Service Bulletin

**REFRIGERATION
ICEMAKER
TOO MUCH ICE**

REF 13-04

**Icemaker Feeler Arm
WR49X10103**

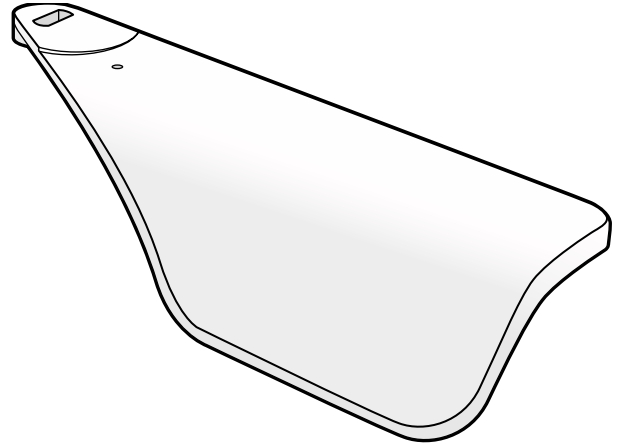
Service calls for continuous ice production, too much ice in the bucket, ice cubes overflowing the bucket, ice cubes falling behind the bucket or ice lifting the chiller shelf can now be resolved by installing a redesigned feeler arm.

The new arm is designed with a slight curve to cycle the icemaker "OFF" before the cubes overflow the ice bucket. Order part number WR49X10103.
